Comments on “A model-based design methodology for the development of mechatronic systems”

Kleanthis Thramboulidis

In the paper by G. Barbieri *et al.* (*Mechatronics* (2014), <http://dx.doi.org/10.1016/j.mechatronics.2013.12.004>), a design methodology, based on the W life cycle process model, is presented and SysML is proposed as a tool to support the whole development process. In this letter, we discuss the presented approach, we point out technical errors and raise additional issues that might help in making the proposed approach applicable.

Fig. 1. The context diagram of the SoI [1].

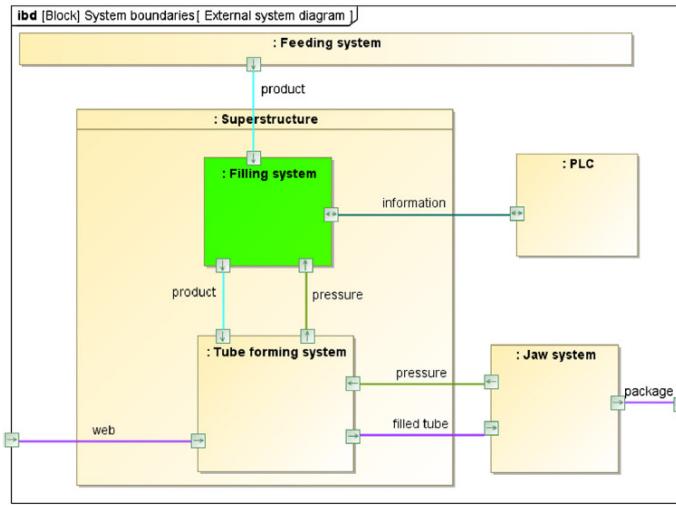
From the context diagram (external system diagram for the authors) given in Fig. 1 ([1, Fig. A.8]), which represents in green the SoI, i.e., the filling system, it is obvious that authors consider the PLC, and subsequently the software that is executed on it as an external entity that interact with the filling system with a connector through which information is exchanged. This means that the SoI, shown as part *:Filling system*, represents just the mechanical unit filling system, of the Tetra Pak filling machine.

According to the context diagram of the SoI (Fig. 1), the superstructure is composed of the *:Filling system* and the *:Tube forming system*, which is not consistent with Fig. 2a. The SoI interacts with the part *:Tube forming system* through the *product* and *pressure* connectors. However, in the sequence diagram of Fig. 3 ([1, Fig. A.9]) the *:Filling system* block accepts *Liquid level feedback* from the *:Tube forming system* which is not consistent with Fig. 1. It should be noted that the PLC, that is assumed to execute the controlling software for the whole machine, does not interact with any other part of the filling machine, which raises many questions on the correctness of the model.

Authors use the term information to show that information flows through the connector connecting the SoI and the *:PLC*. It should be noted that information may be processes, transferred and stored, and this can be performed using either software, electronics or mechanics. Information may be transferred either by data exchange, by signal, or even by pressure or force. For example the connector between the *:Tube forming system* and the *:Jaw system* that is named *pressure* may represent just information transfer between the interacting systems. Based on this reasoning the naming but mainly the convention of the authors to use colors to increase the comprehension of the model is not only effectless but may lead to errors in modeling. It is also questionable why authors claim that electrical (interactions) are not specified in the context diagram but are defined after the detailed system design [1, Sec. 3.1.2].

Fig. 2. The Tetra Pak filling machine part of which is the SoI [1][14].

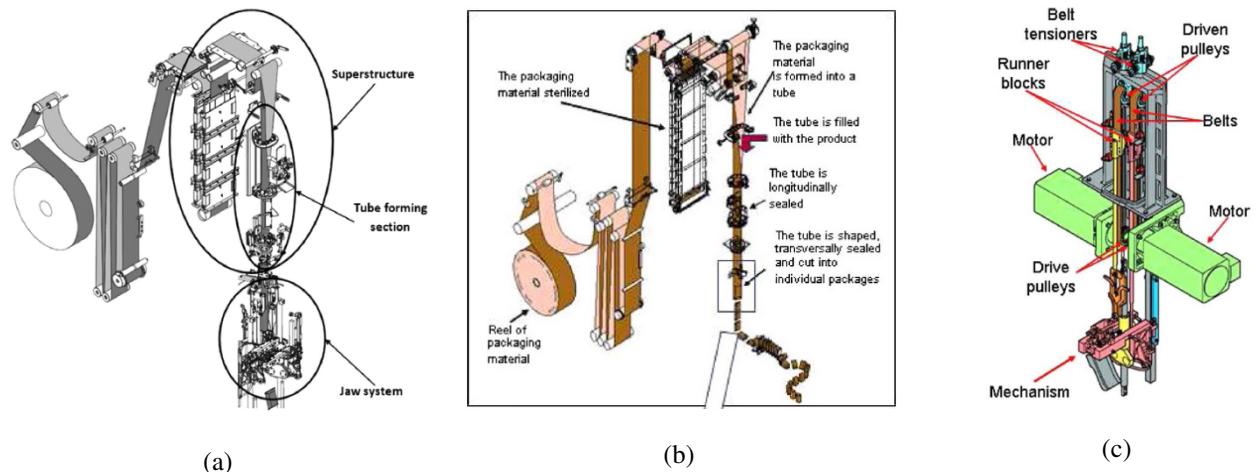
Fig. 2a ([1, Fig. 6]) represents, taking into account also Fig. 2b ([14, Fig. 2] and Fig. 2c ([14, Fig. 3]), the mechanical part of the Tetra Pak filling machine and in this sense the PLC and the controlling software that is executed on it are considered as external entities as captured in the context diagram of Fig. 1 ([1, Fig. A.8]). Based on Fig. 2, the mechanical part of the Tetra Pak filling machine is composed of a part that is called superstructure, which interacts with the other part that is called Jaw system. The superstructure is composed of the Tube forming section and another part that is not named. It is a question why the filling system is not shown in this figure.

Fig. 4. Internal block diagram of the Filling system [1].

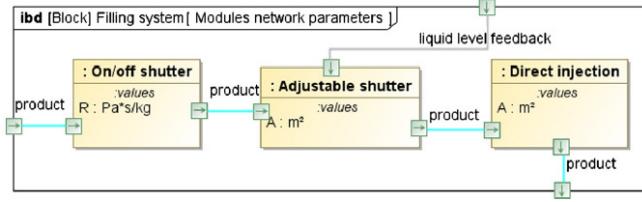
Through the above process authors claim that they have identified four functions that have to be performed by the SoI, and assign these to an equal number of modules shown in Fig. 4 ([1, Fig. A.10]). It should be noted that the ibd of this figure is not consistent with the context diagram since the Filling system appears to have as input *liquid level feedback*, which is not shown in Fig. 1 ([1, Fig. A.8]). Moreover, *pressure* and *information flow*, shown in the context diagram, do not appear in the Filling system ibd.

According to the context diagram given in Fig. 1, the *:Filling system* represents only the mechanical part of the Filling system. This means that the parts of the ibd of the Filling system shown in Fig. 4 represent also mechanical parts but this is not consistent with the functional architecture of the adjustable shutter presented in Fig. 5. A mechanical part, i.e., the *:Adjustable shutter*, appears to execute computational activities, such as *:Calculate correction*. Furthermore, it seems that the *:Receive liquid level feedback* accepts as input the *liquid level feedback* shown in the ibd of Fig. 4 but it is a question of how the output of the *:Calculate correction* activity affects the system since there is no related output at the corresponding ibd.

Fig. 6. Servomotor state machine [1].

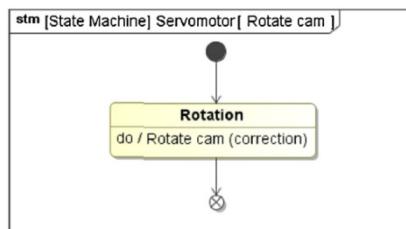
Authors after defining the functional architecture of the *adjustable shutter* they identify a servomotor as a component for actuating the correction and describe the behavior of this component by using the state machine shown in Fig. 6 ([1, Fig. A.12]). Based on this state chart, the servomotor performs just one operation and has only one state, the one that represents the rotation of the cam. It is not clear what exactly this state machine represents and which are the conditions that fire the transitions. Does it represent the states of the mechanical servomotor, the states of its controlling software entity or something else?
